Access Compliance Report

Public Rights-of-Way

(Curb Ramps)

Intersection ID: 4753	Main Street: LOWEN_RD	Cross Street: SADDLE_TRAIL_LN	Location: NW
ADA ID: 9F93EC236628	Ramp Type: PerpDiag	Initial Pass/Fail: Fail	Overall Compliance: No
			Severity Score: 18.75

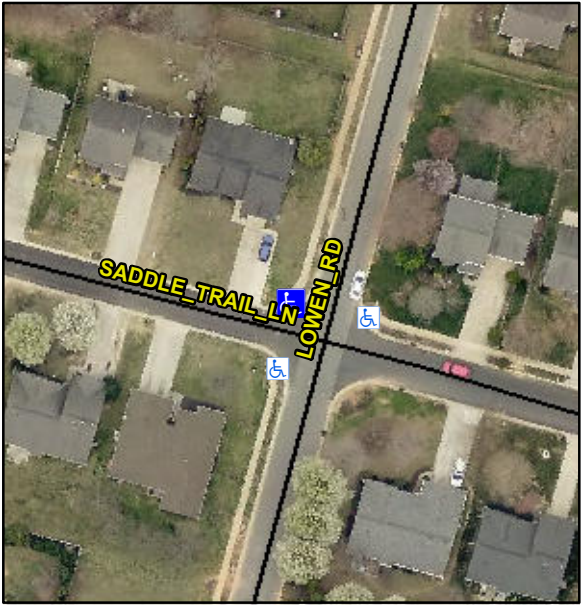
Codes/Mitigation Info/Possible Solution			Field Measurements/Component Compliance		
	Possible Solutions:		Compliance	Description	Data
	Remove & Replace Curb Ramp With Two New Directional Ramps or Equivalent.		Yes	Ramp Length (in)	6.3
			No	Ramp Width (in)	4.1
			N/A	Flare Type LT	N/A
			N/A	Flare Slope LT (%)	N/A
			N/A	Flare Traversable LT?	N/A
			N/A	Landing Length (in)	N/A
			N/A	Landing Width (in)	N/A
			N/A	Landing Slope (%)	N/A
			N/A	Landing X Slope (%)	N/A
<p>Surveyor Notes:</p> <p>N/A</p> <p>PROW/ADA:</p> <p>Not Found, R304.5.1, R304.5.3</p>			N/A	Flare Type RT	N/A
			N/A	Flare Slope RT (%)	N/A
			N/A	Flare Traversable RT?	N/A
			N/A	DWS Provided?	N/A
			N/A	DWS Contrast?	N/A
			N/A	DWS Length (in)	N/A
			N/A	DWS Full Width?	N/A
			N/A	DWS Offset (in)	N/A
			N/A	Shared Landing?	N/A
			N/A	Gutter Ponding?	N/A
			N/A	Gutter Lip Ht (in)	N/A
			No	Painted X Walk1?	No
				X Walk 1 Direction	To S
			N/A	X Walk 1 Width (in)	N/A

10.5	X Walk 1 Slope (%)	7.9
			3.4	X Walk 1 X Slope (%)	12.3
			N/A	Ramp inside XWalk1?	N/A
			3.4	Road Slope (%)	N/A
			9.0	Road X Slope (%)	N/A
			N/A	Any Obstructions?	N/A
				Obstruction Type	
			N/A		N/A
			N/A		N/A
			Yes	Surface Condition? (G/P)	Good
